Request for Revision of Monitoring Plan
“Enercon Wind Farm (Hindustan) Ltd in Karnataka”

CDM Registration No: 1259

Validation opinion as per requirement of EB49, Annex 28, para 7

The project metering arrangement is as follows:

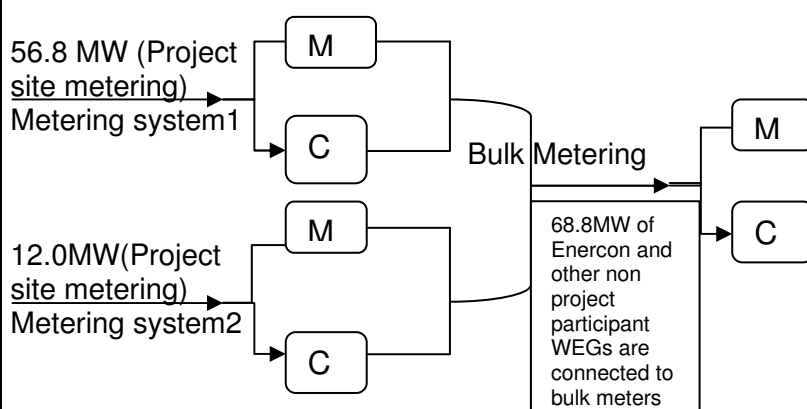
In the registered PDD under metering equipment it is mentioned that the “the metering system for the project activity consists of one main meter and one check meter”. But as per the information gathered during the site visit there are two separate feeder line exclusively for the project activity, each feeder has separate main and check meter. In addition to that the information on bulk meter installation and procedure for calculation of transmission losses have not mentioned in the PDD, but the same has been reflected in the signed PPA.

The calibration frequency is not mentioned in the registered PDD.

1. All the energy meters belong to the project activity will be tested for accuracy at least once in a year as per national standards (As per the CEA Notification No.: 502/70/CEA/DP & D dated

17/03/2006, calibration interval should be of at least once in 5 years.). KPTCL or BESCOM will be in charge for yearly calibration of energy meters.

2. All the energy meters will be sealed and kept it under the custody of state utility.
3. For monthly joint meter, billing and invoice purpose, the main meter readings will be considered as long as the error identified by the main meter is with in the permissible error of 0.2 accuracy class. If there is any discrepancy in accuracy of main meter identified during calibration, the energy generation by the WEGs will be monitored as per the procedure set out in PPA and Annex-4 of the revised monitoring plan.

The above adopted procedure is verified by reviewing PPA, calibration report and interview with state utility and Enercon. Thus the DOE concludes that the QA/QC approach followed by the state utility will result in reliable quality of emission achieved by the project activity.
